PROJECT: Wayne RESA
Bid Package T1- Access Control System

DATE: September 28, 2020

The purpose of this addendum is to clarify information that has been gathered after the release of the project manual, drawings and specifications for the Wayne RESA Bid Package T1. Information from Addendum 2 is included. The following information is included in the Contract Documents.

First Floor - Unit C
Security Plan
Wayne RESA

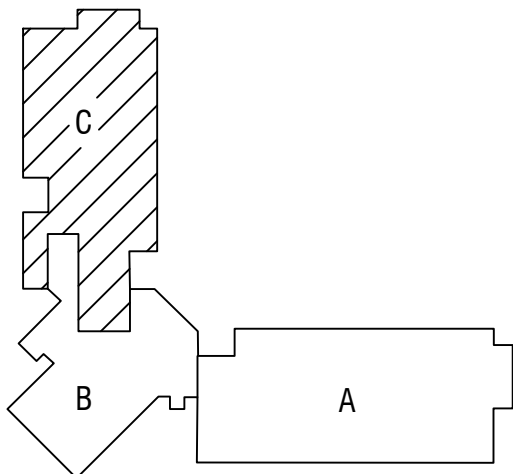
Q. Do doors B.1.I.3 (Wayne RESA Bldg.) and C.1.E.2 (Wayne RESA Bldg.) need to have a card reader and keypad or card

reader only?

A. B.1.I.3 is a new access control door and will require a new reader (wall switch style). Door C.1.E.2 is an existing access control door but will need its current reader replaced with a new card reader (mullion style). No keypads required on both doors.
